Access Compliance Report

Public Rights-of-Way

(Curb Ramps)

Intersection ID: 18584	Main Street: NOTTINGHAM_DR	Cross Street: ROBINHOOD_RD	Location: E
ADA ID: 4E0CA998BEB7	Ramp Type: PerpDiag	Initial Pass/Fail: Fail	Overall Compliance: No
Severity Score: 8.75			
Codes/Mitigation Info/Possible Solution		Field Measurements/Component Compliance

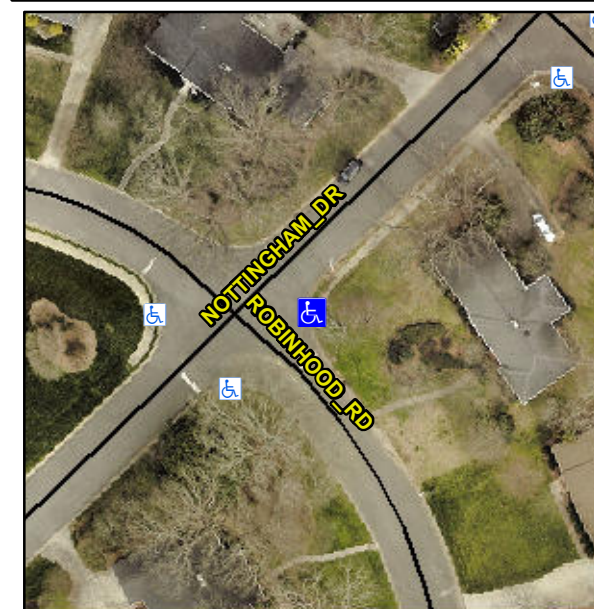
Not Found, R304.5.1

Compliance	Description	Data	Compliance	Description	Data
N/A	Ramp Length (in)	24.5	Yes	Ramp Slope (%)	7.8
No	Ramp Width (in)	44.5	Yes	Ramp XSlope (%)	1.4
N/A	Flare Type LT	N/A	N/A	Flare Type RT	N/A
N/A	Flare Slope LT (%)	N/A	N/A	Flare Slope RT (%)	N/A
N/A	Flare Traversable LT?	N/A	N/A	Flare Traversable RT?	N/A
N/A	Landing Length (in)	N/A	N/A	DWS Provided?	N/A
N/A	Landing Width (in)	N/A	N/A	DWS Contrast?	N/A
N/A	Landing Slope (%)	N/A	N/A	DWS Length (in)	N/A
N/A	Landing X Slope (%)	N/A	N/A	DWS Full Width?	N/A
N/A	Landing Curb? (Y/N)	N/A	N/A	DWS Offset (in)	N/A
N/A	Shared Landing?	N/A			
N/A	Gutter Ponding?	N/A	N/A	Gutter Slope (%)	N/A
N/A	Gutter Lip Ht (in)	N/A	N/A	Gutter X Slope (%)	N/A
N/A	Painted X Walk1?	No	N/A	Painted X Walk2?	No
	X Walk 1 Direction	To NW		X Walk 2 Direction	To SW
N/A	X Walk 1 Width (in)	N/A	N/A	X Walk 2 Width (in)	N/A
	X Walk 1 Slope (%)	1.2		X Walk 2 Slope (%)	0.8
	X Walk 1 X Slope (%)	0.9		X Walk 2 X Slope (%)	2.6

Remove & Replace Curb Ramp With Two New Directional Ramps or Equivalent.
